LINCOLN CITY/LANCASTER COUNTY PLANNING STAFF REPORT

for February 16, 2005 PLANNING COMMISSION MEETING

P.A.S.: Use Permit #145A - Pine Lake Plaza

PROPOSAL: To adjust the O-3 district sign requirements to allow additional ground signs, and to allow signs near driveways instead of at building entrances.

PINE LAKE PLAZA
SITE EXHIBIT
Lincoln, NE

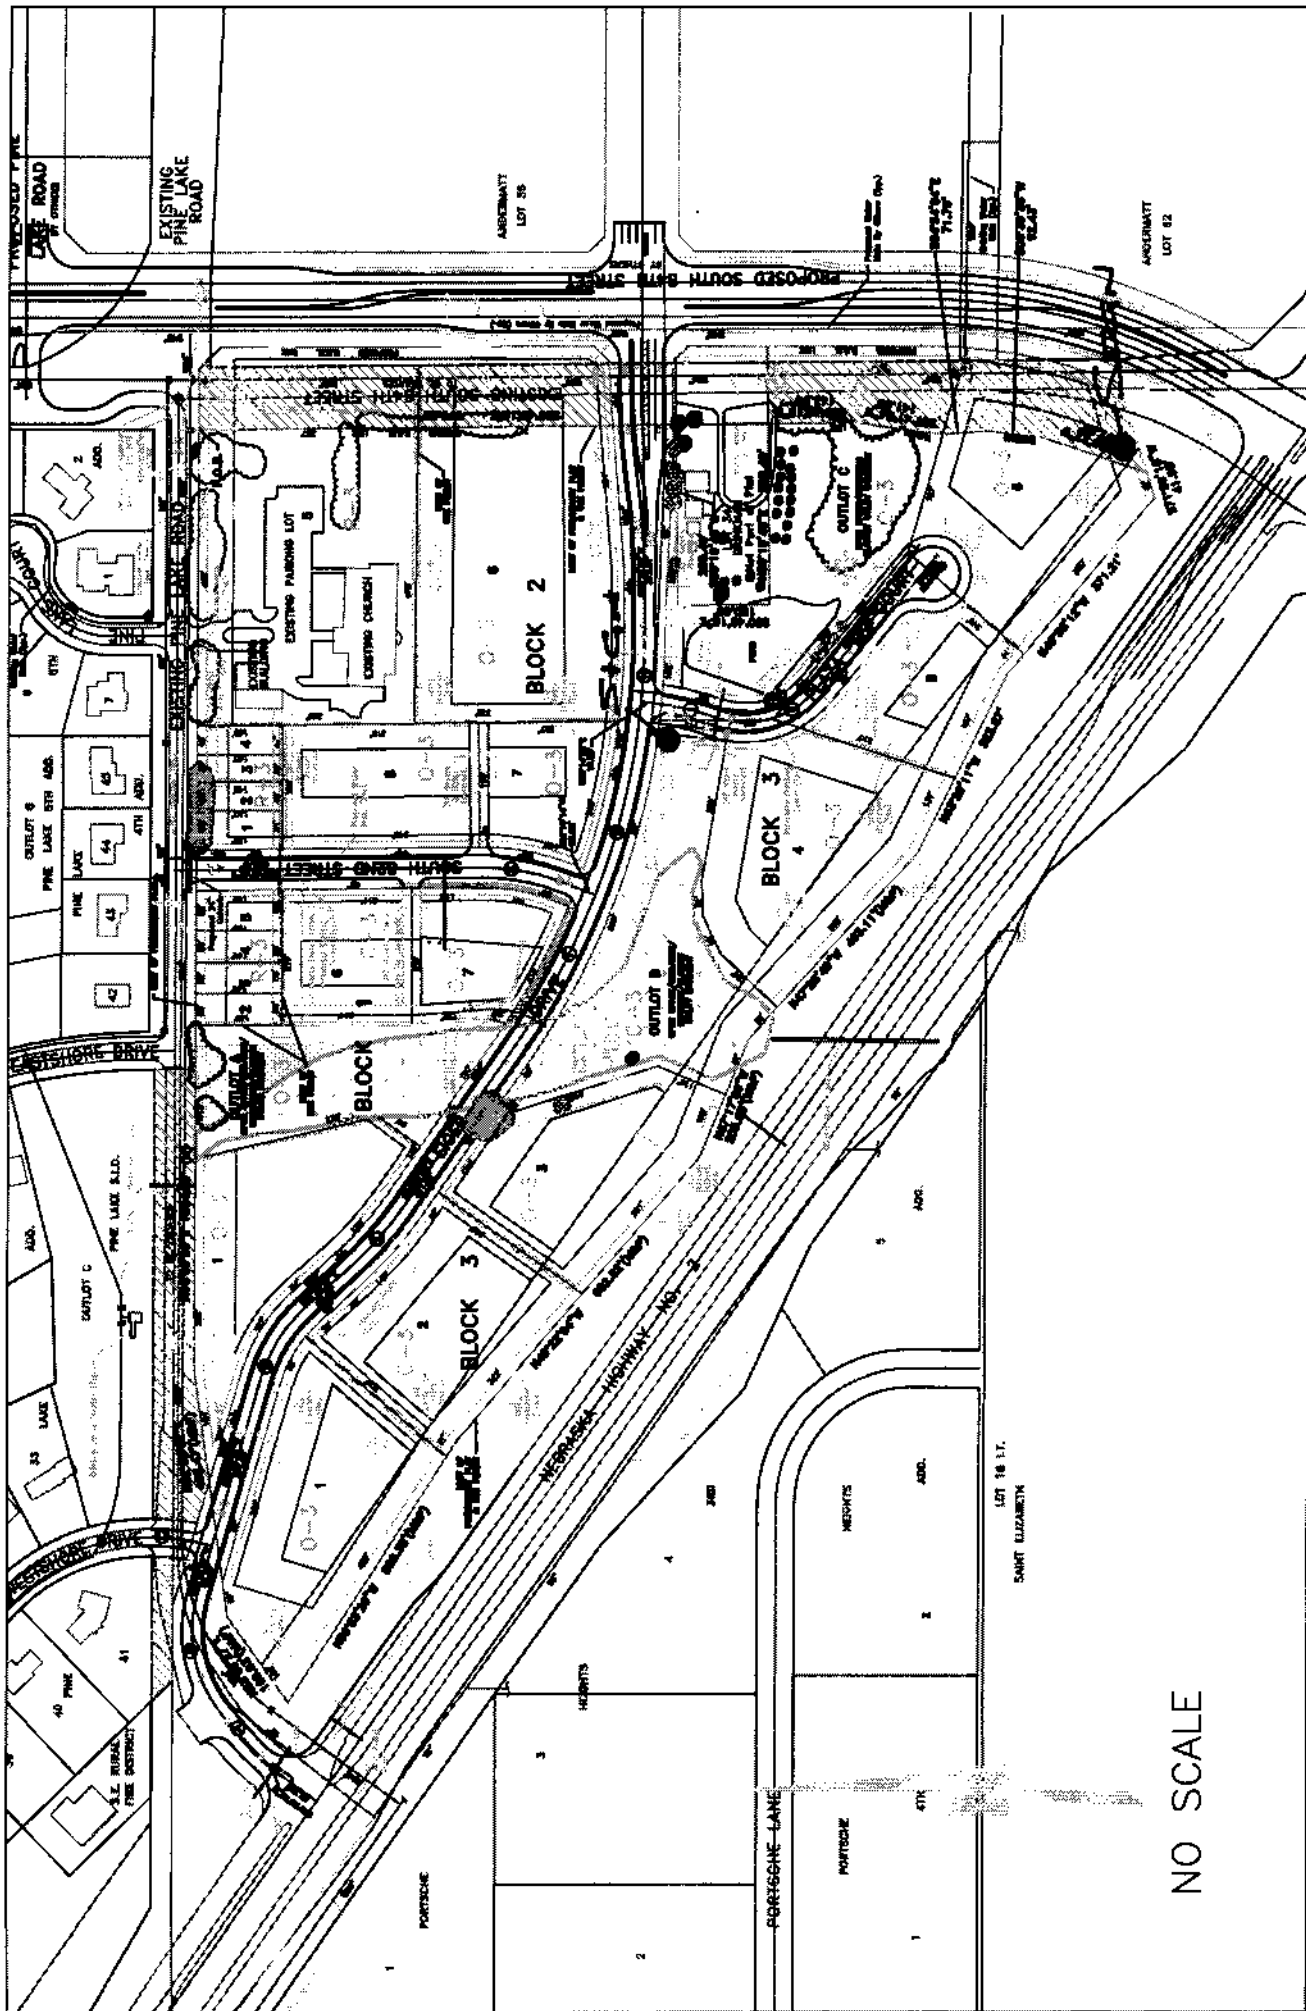
However, Public Works and Utilities notes in their review a concern about signs and proper sight-distance without future driveways shown on the site plan. They want to ensure signs are not built in locations that may interfere with a driver's vision when entering or exiting the driveways throughout the development. Building and Safety is aware of this concern, and confirmed that as part of the sign permit review they always review for proper sight-distance, satisfying Public Works' concern.

5. The second component of this request seeks two additional ground signs (32 sq. ft. each) while relinquishing the right to use the internal direction signs. The intent of this request is twofold. First, it is to provide a direction sign at the intersection of Eiger Drive and Plaza Court, and second, to provide an additional ground sign on Lot 6,

Block 3 to identify only a single business at the intersection of Highway 2 and South 84th Street. Internal direction signs (50 sq. ft.) are allowed when they are adjacent to a private roadway, and one is allowed at the intersection of Eiger Drive and Plaza Court (a private roadway). As a result, this request for an additional ground sign is not necessary. Conversely, the applicant is not relinquishing the right to use additional direction signs because only one is allowed.

The proposed sign on Lot 6 at the intersection of Highway 2 and South 84th Street is an additional building identification ground sign for a single business, and is neither justified nor appropriate. The proximity to Highway 2 is a significant concern, as much effort has gone into preserving and protecting Highway 2 as an entryway corridor. Signs in this area are contrary to those efforts and the Comprehensive Plan. Staff is also concerned that this adjustment will establish a precedent, and that similar exceptions will be sought for other lots adjacent to the highway. The on-premise wall sign can be used to identify the building and its use.

- Without knowing the locations of the future driveways and sign envelope locations, Public Works cannot recommend a blanket approval of the proposed language changes with this permit.
- Public Works also has concerns of the eventual sign height on Lot 6. Contours show the lot about 12' lower than the curb heights of the adjoining roadways.
- The corridor of Highway 2 should be protected, and with approval of one lot sign, the potential for five more signs facing the highway exists.

1. This approval adjusts the sign requirements for the O-3 district to allow building identification ground signs at locations other than near the building entrance.

2. Before receiving building permits:
 - 2.1 The permittee shall complete the following instructions and submit six copies of the documents and plans to the Planning Department for review and approval.
 - 2.1.1 The site plan revised as follows:
 - 2.1.1.1 Revise General Site Note #24 to read as follows: SIGNS SHALL BE PERMITTED AND LOCATED IN ACCORDANCE WITH LINCOLN MUNICIPAL CODE SECTION 27.69.044 WITH THE FOLLOWING MODIFICATION: ONE GROUND SIGN NOT EXCEEDING 15 SQUARE FEET IN AREA AND 5 FEET IN HEIGHT SHALL BE PERMITTED AT EITHER EACH BUILDING ENTRANCE OR AT EACH VEHICULAR ENTRANCE PER LOT PROVIDED THE SIGN DOES NOT OBSTRUCT SIGHT DISTANCE.

2.1.1.2 Delete General Site Note #25.

2.1.1.3 Revise General Site Note #26 to read as follows: DETAILS OF ALL SIGNS, INCLUDING TYPE, LOCATION, HEIGHT AND SIZE WILL BE SUBMITTED SEPARATELY FOR REVIEW FOR SIGN PERMITS. SIGNS WHICH MEET THE REQUIREMENTS OF THE ZONING ORDINANCE AND THE REQUIREMENTS OF GENERAL SITE NOTE #24 ARE NOT REQUIRED TO BE SHOWN ON THE SITE PLAN AND NO ADMINISTRATIVE AMENDMENT IS REQUIRED.
